EVALUATION OF WET AND GAS HELIUM EXPANSION ENGINES
(Fermilab Reciprocating Design)

PREPARED UNDER FERMILAB SUBCONTRACT NO. 94199
BY CRYOGENIC CONSULTANTS, INC.
ALLENTOWN, PA.

FERMI NATIONAL ACCELERATOR LABORATORY
BATAVIA, ILLINOIS

10 July 1979

SKETCH NO. 1

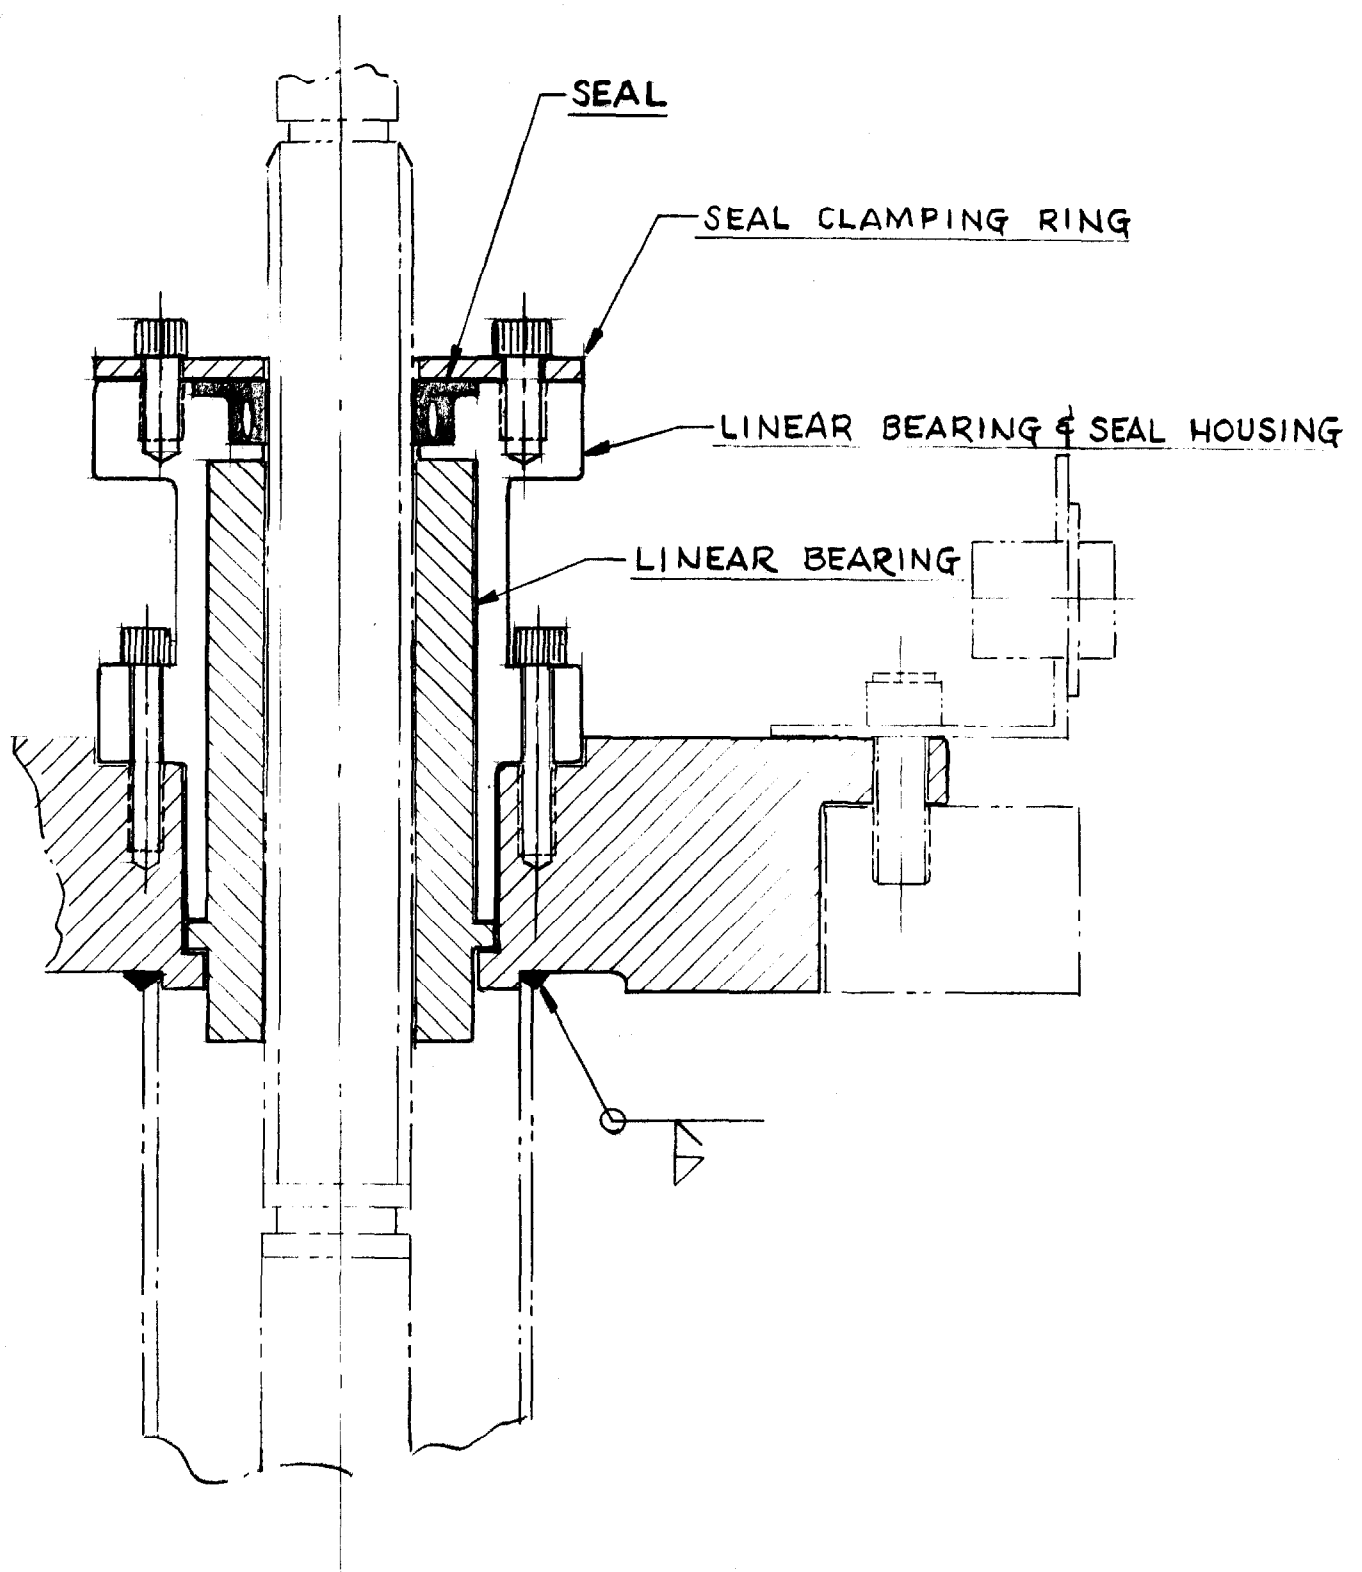
The present design positions the shaft seal below
   the linear bearing. In order to inspect or change
   the seal, the entire bearing assembly must be removed.
   If there is a seal leakage, the resulting cold shaft
   will form ice crystals, attract water, and possibly
   grit particles into the bearing raceway.

It is recommended that the shaft seal be relocated
   above the linear bearing for the following reasons:

A tentative layout of a revised bearing and seal
   housing is shown on Sketch #1.

SKETCH NO. 2

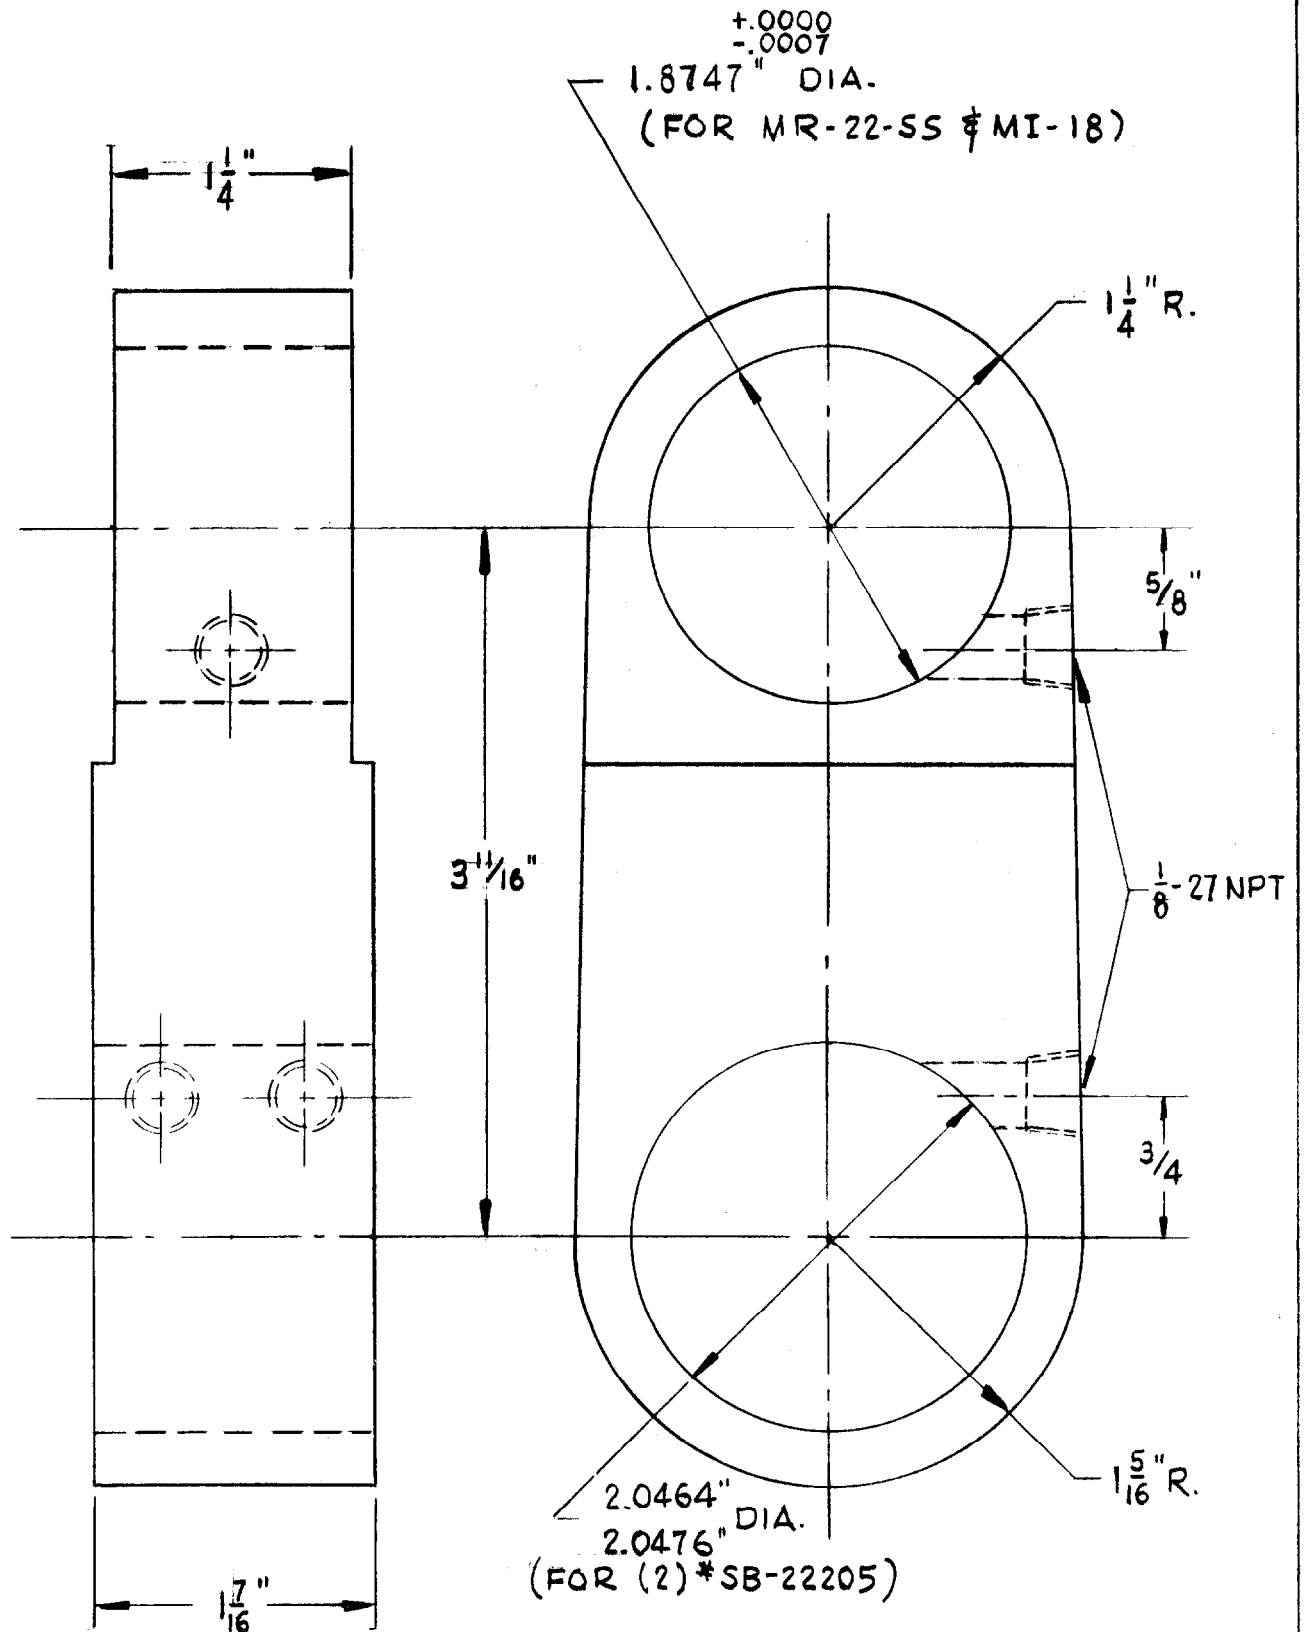
It is recommended that the crank bearing be changed to two McGill No. SB-22205 Sphere-Rol bearings. The life expectancy is improved to 30,000 hours at 500 cycles per minute. This bearing can be fitted into the present design by increasing the width of the connecting rod from 1-1/4 to 1-7/16 in. at the crank and reducing the thickness of the crank spacers accordingly. A drawing showing a connecting link revised to hold the larger bearing is shown in Sketch #2.

1. Increase allowable tolerance, call for correct bore per bearing handbook, and eliminate sawcut and clamping bolts. (See sketch No. 2.)
